Observations of Floodway Definition for the  
Congaree River in Richland and Lexington  
Counties, SC

## Overview

## Calibration of 1D to 2D?

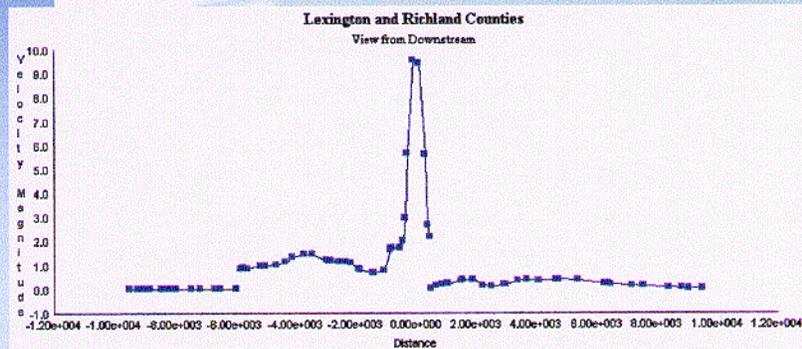
- Impossible if 2D conditions exist
- Curve in 2D – Straight Line in 1D

## Velocity Parallel to River

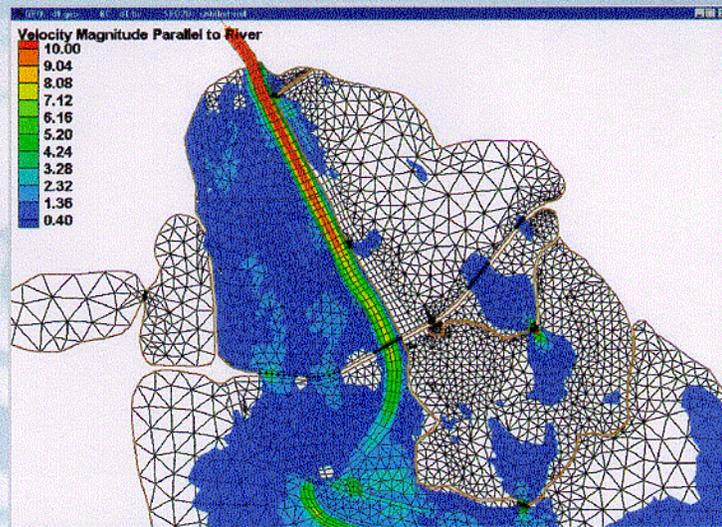
**Flow in Richland County is not consistent with effective flow in a floodway.**

- Velocity parallel to river on Richland floodplain generally less than 0.4 ft/sec.
